REMARKS

Prior to examination on the merits on this divisional application, Applicants respectfully request entry and consideration of this Preliminary Amendment.

FIG. 4

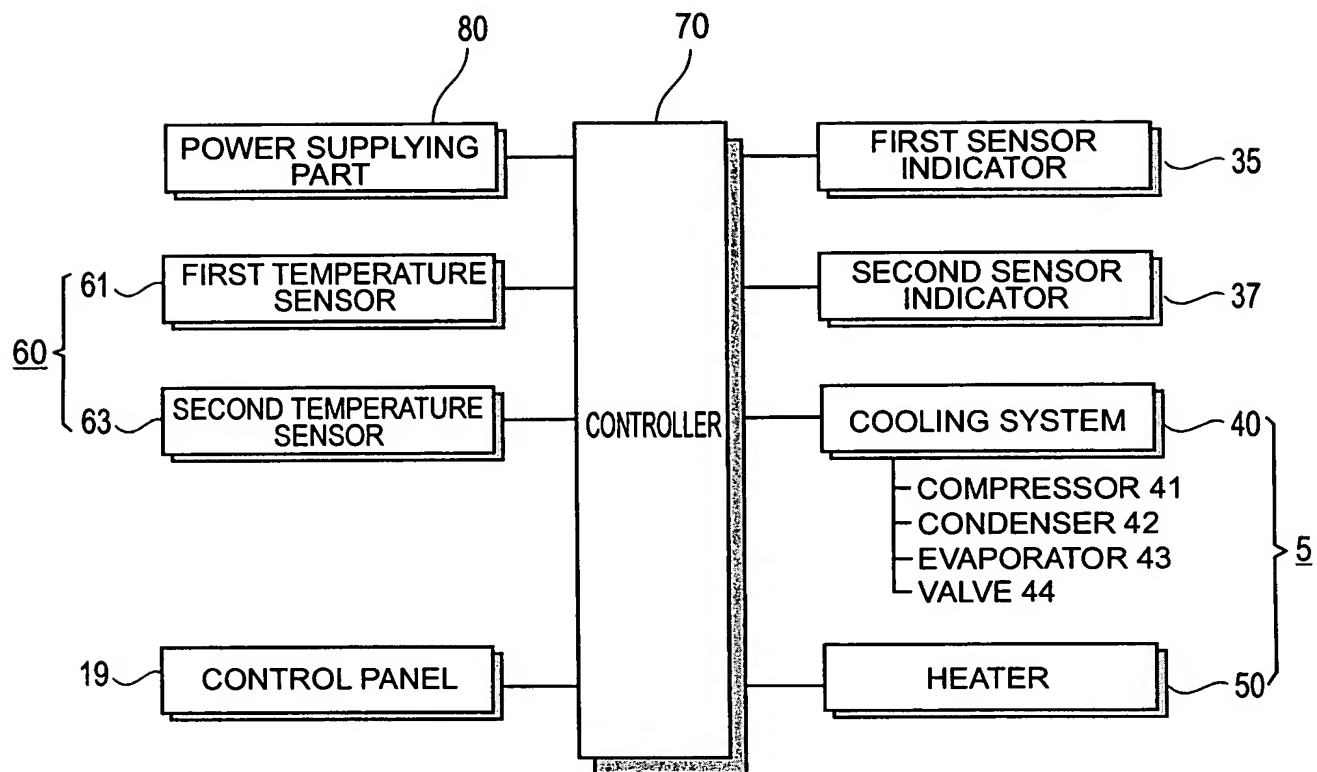
Figure 4 has been amended to show the compressor, the condenser, the evaporator, and the valve.

FIG. 5a

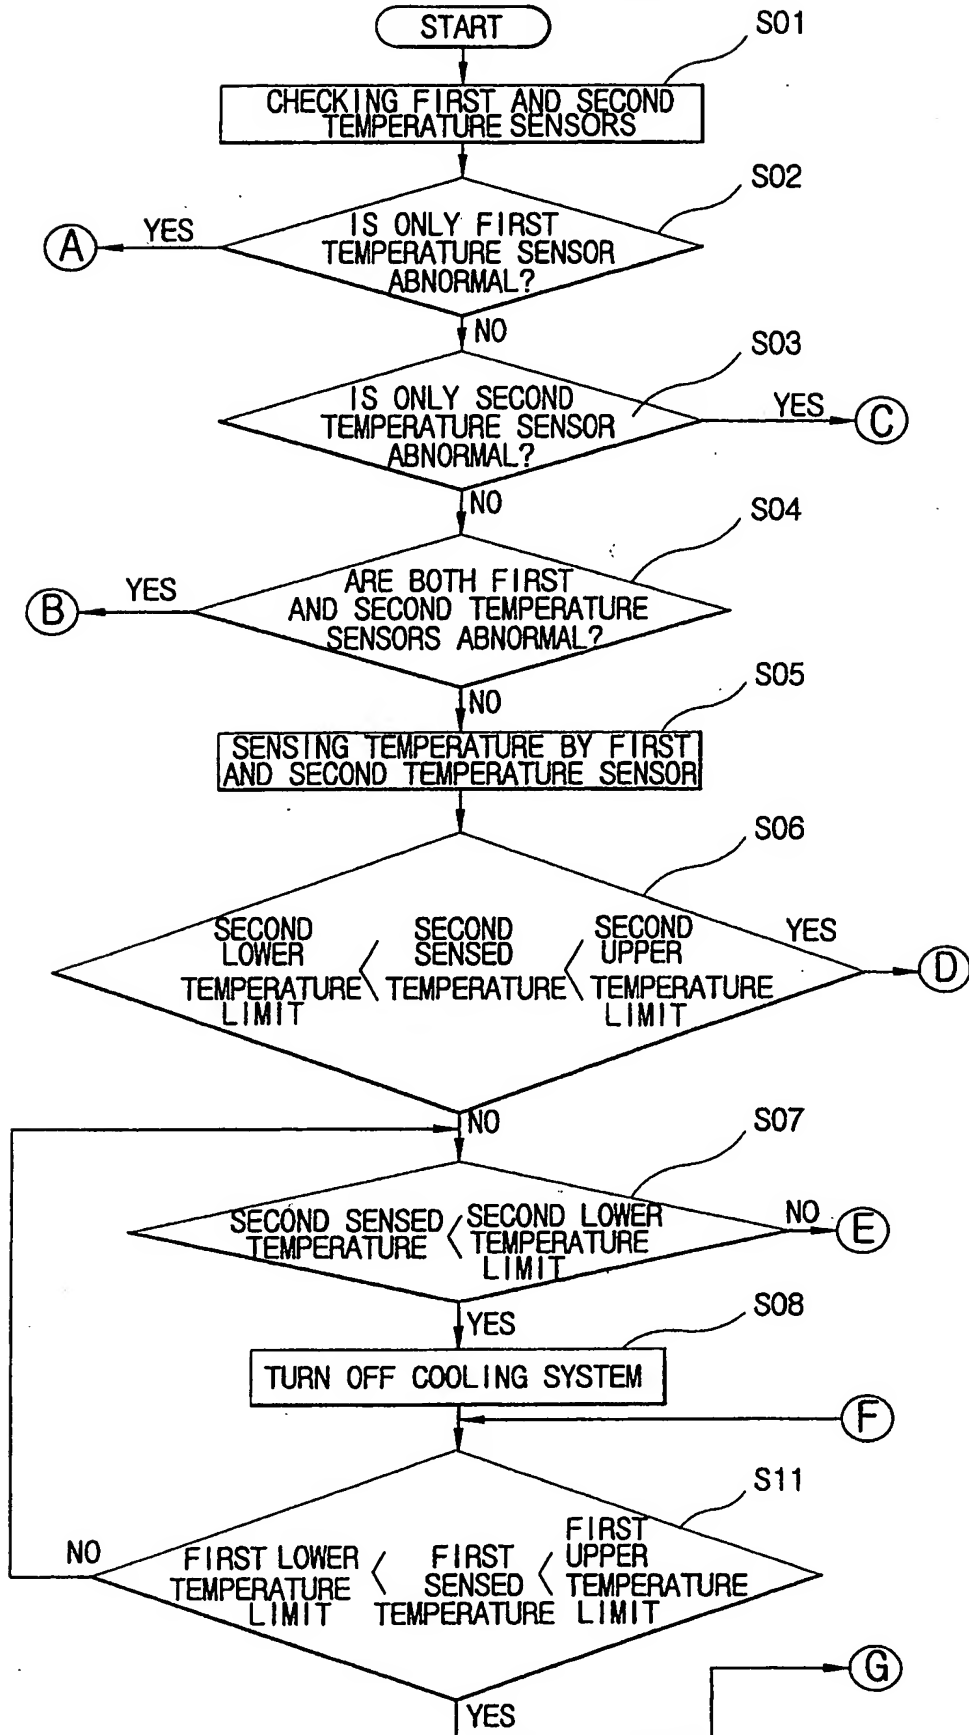
“SENSOR” in step S01 in Figure 5a has been replaced with “SENSORS.”

FIG. 5b

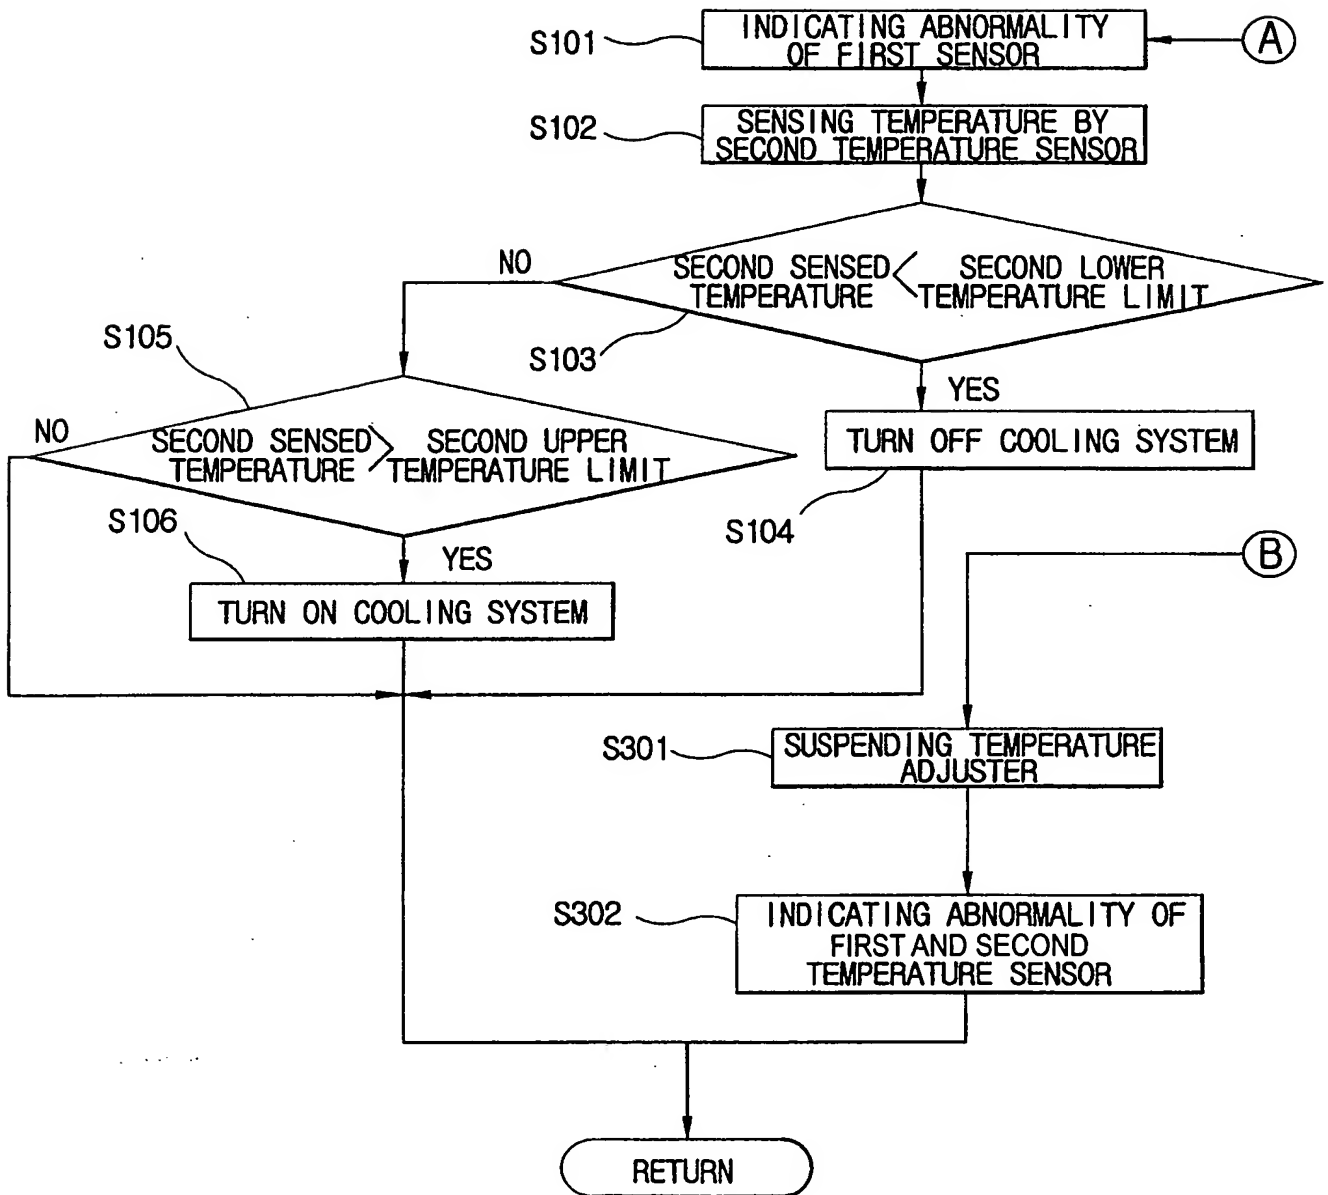
“FIEST” in step S302 in Figure 5b has been replaced with “FIRST.”

FIG. 6a

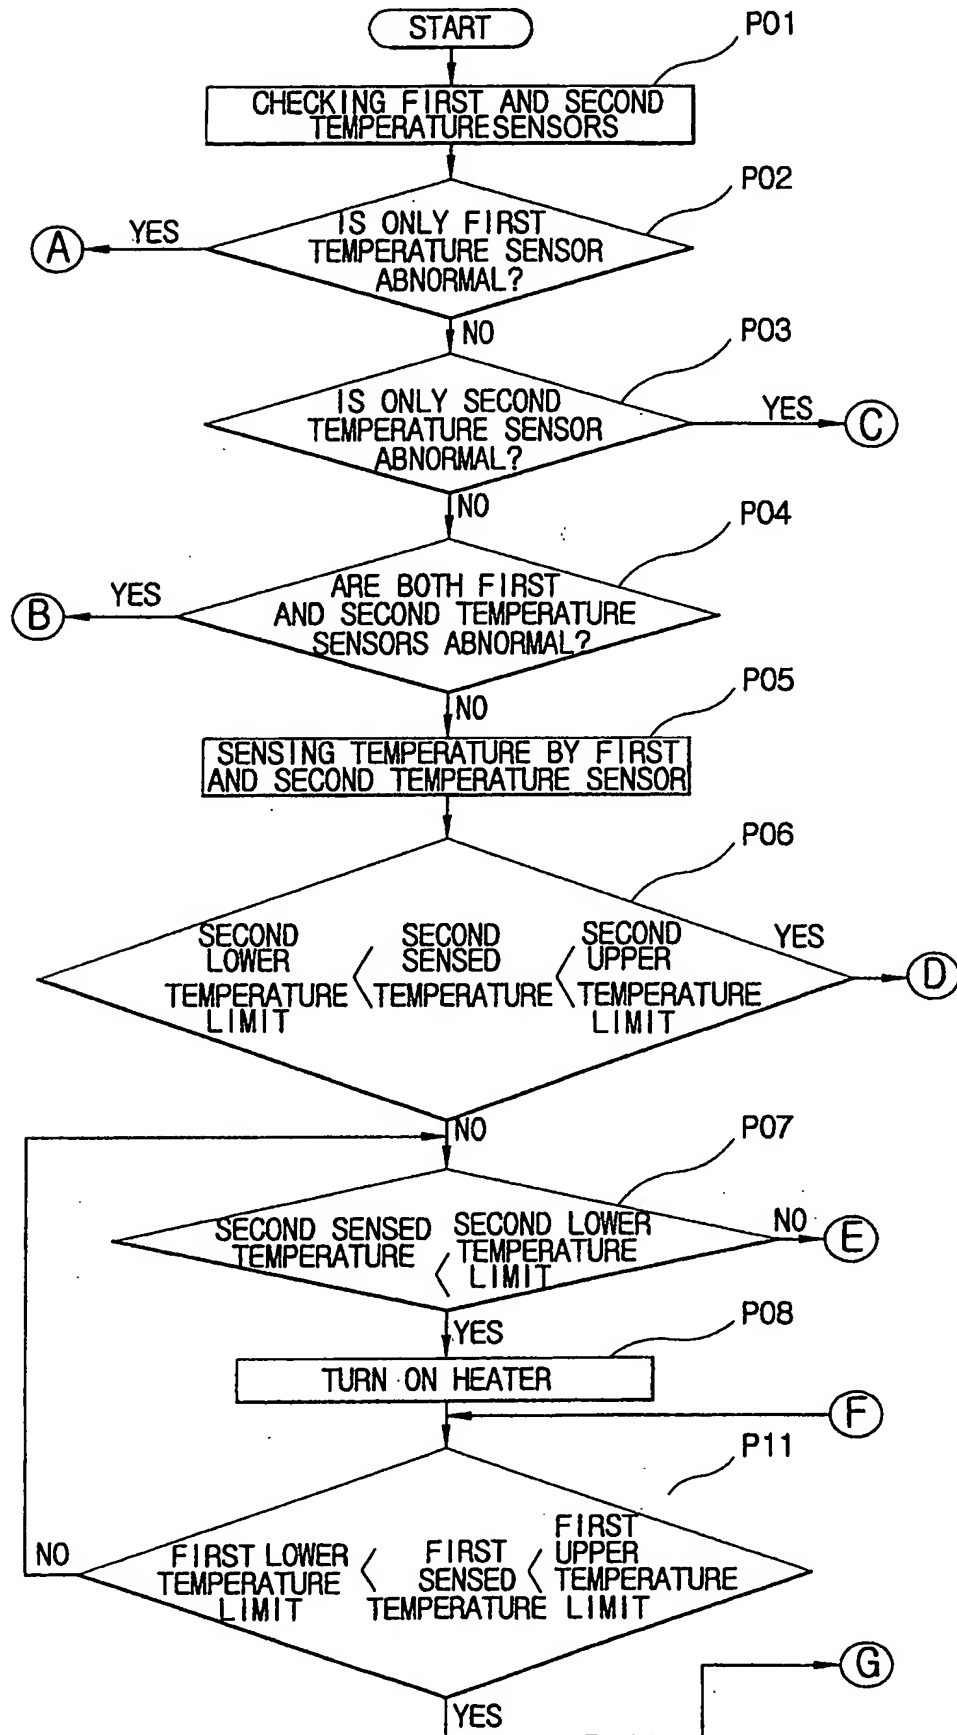
“SENSOR” in step P01 in Figure 6a has been replaced with “SENSORS.”
